ADDENDUM NO.: THREE

DATE: March 4, 2015

PROJECT TITLE: **OUTDOOR EVENTS SHELTER**
UNC CHARLOTTE
SCO ID# 14-11196-01A
WTS Project No. 1432/ File 7.0

WRITTEN BY: Michael Watson, AIA, LEED AP BD+C

1 SITE PLAN - ELECTRICAL
1" = 30'

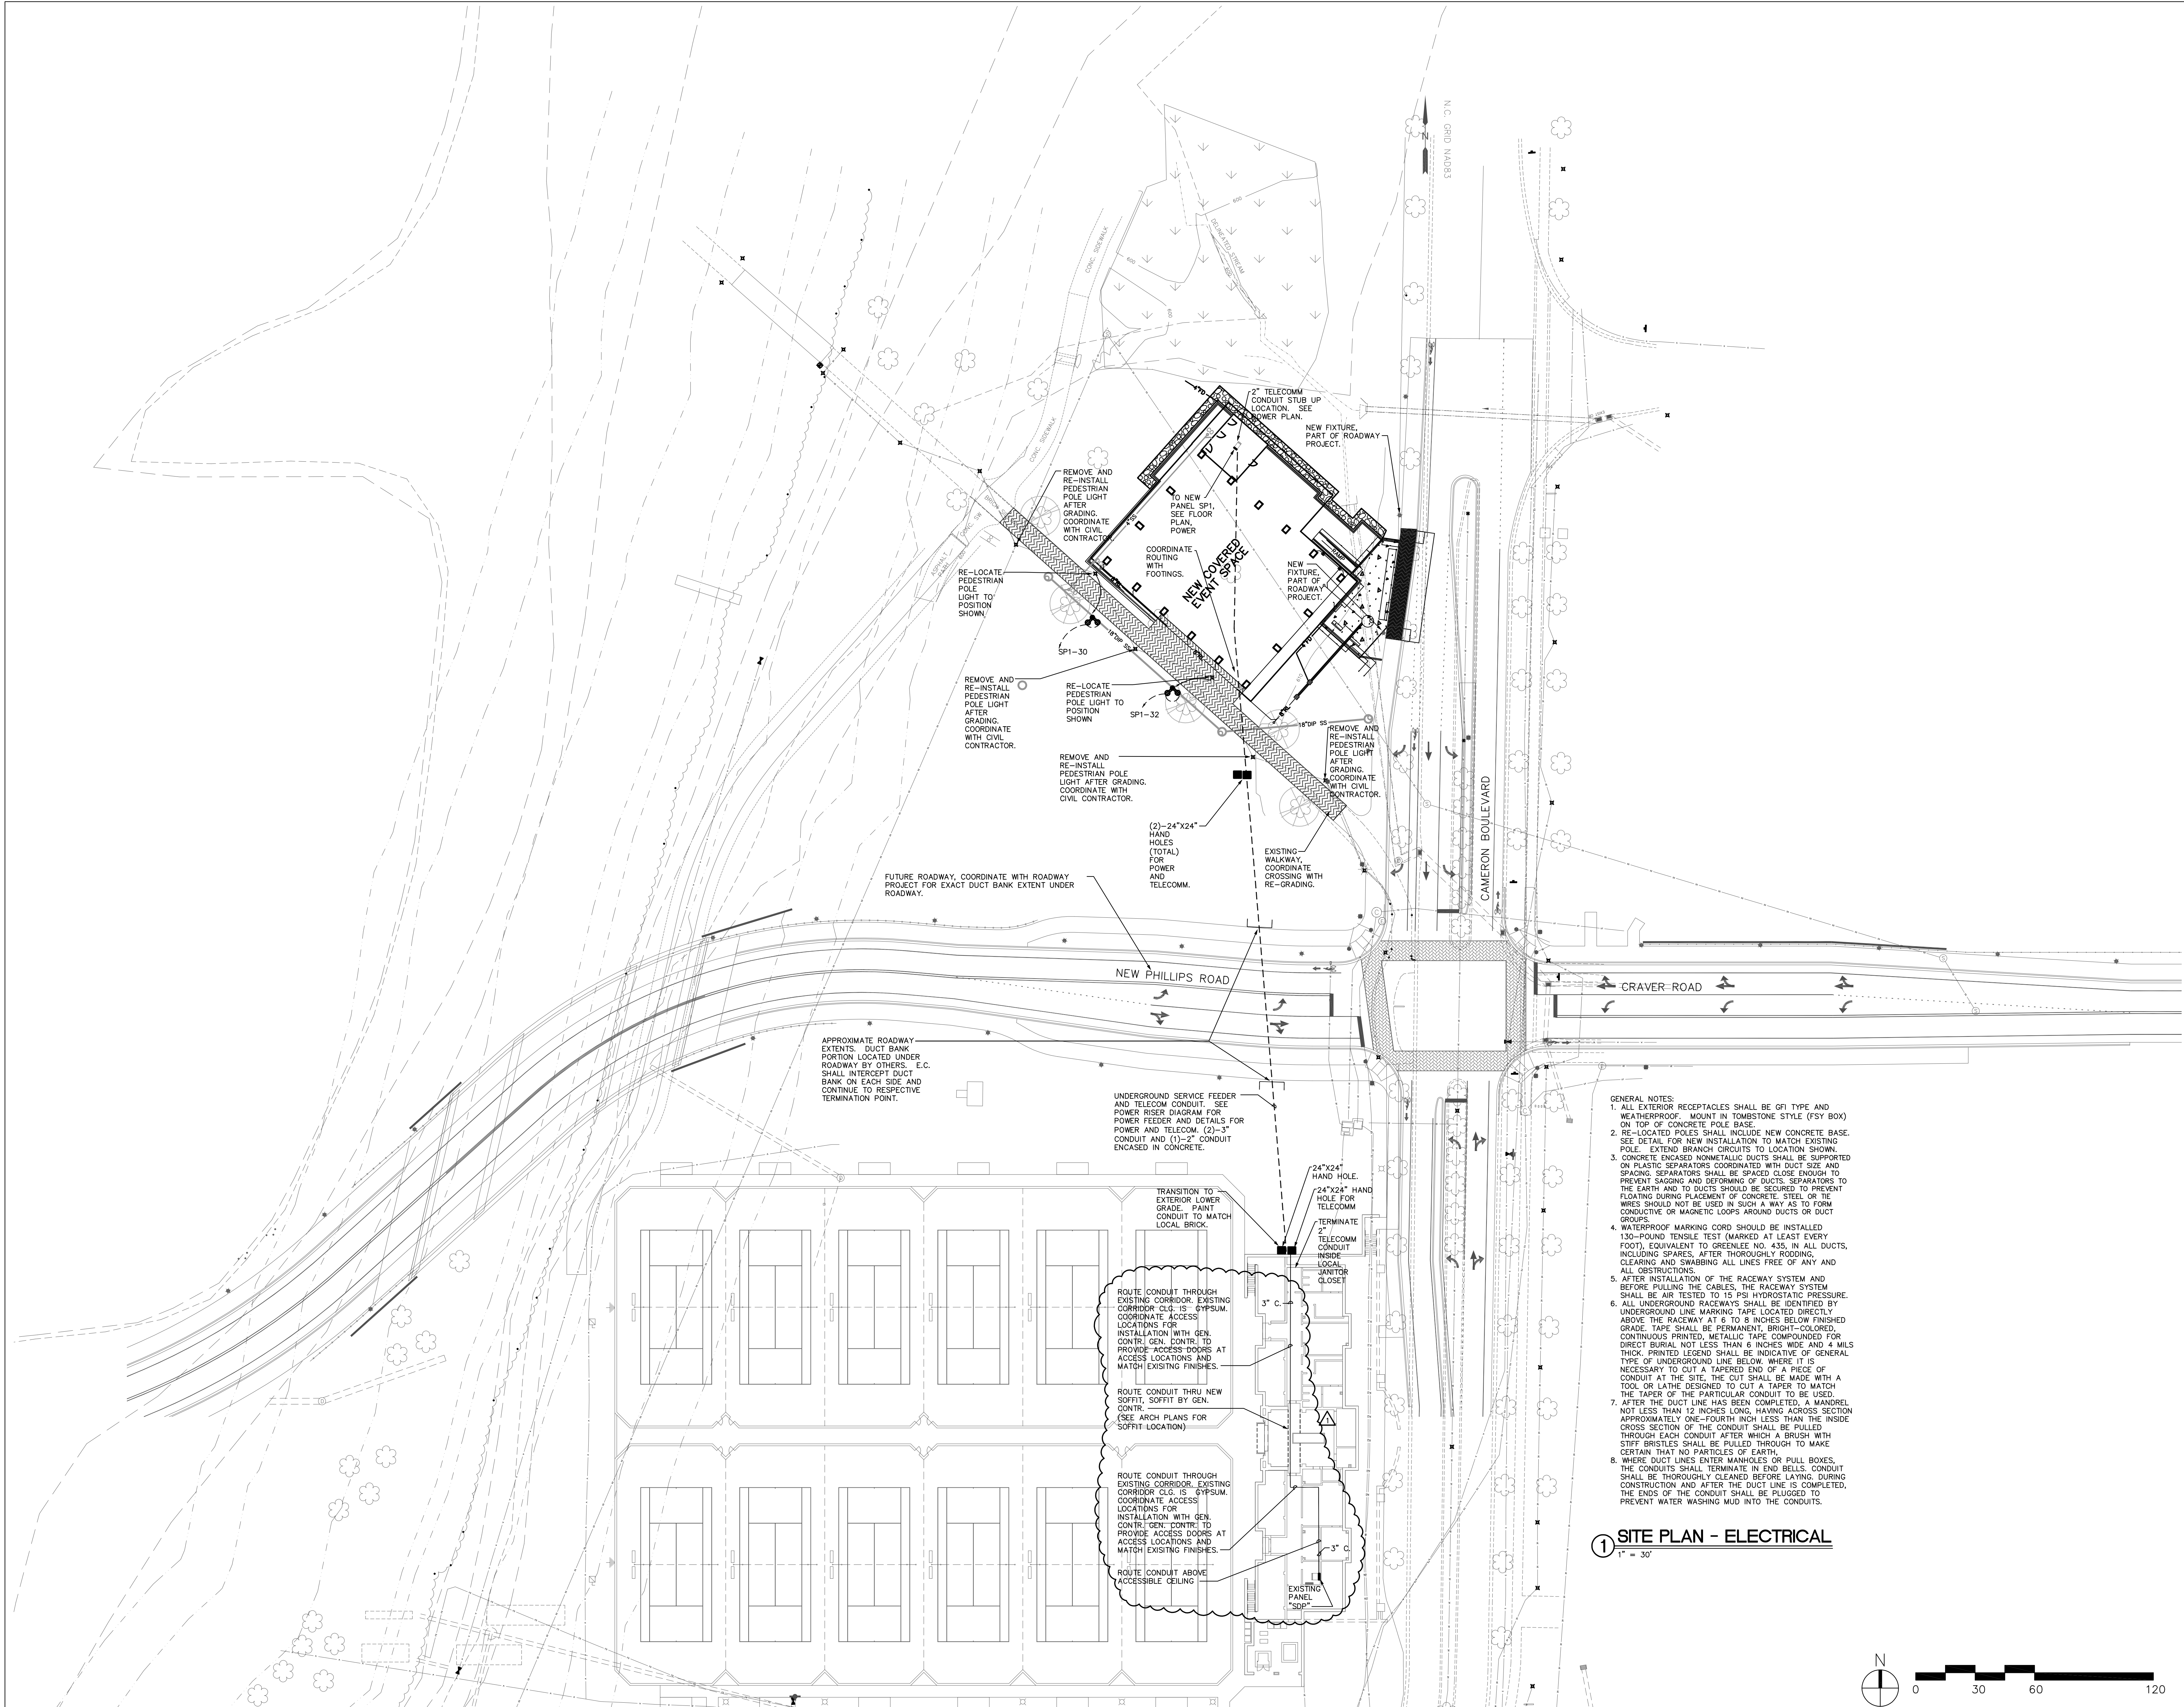
A. Detail 1/E.10 was revised to show a revised routing of the new electrical conduit at the Tennis Center. Further clarification was given for the scope of work required to install the new electrical conduit at the Tennis Center.

3/4/15 TENNIS CENTER CONDUIT ROUTING
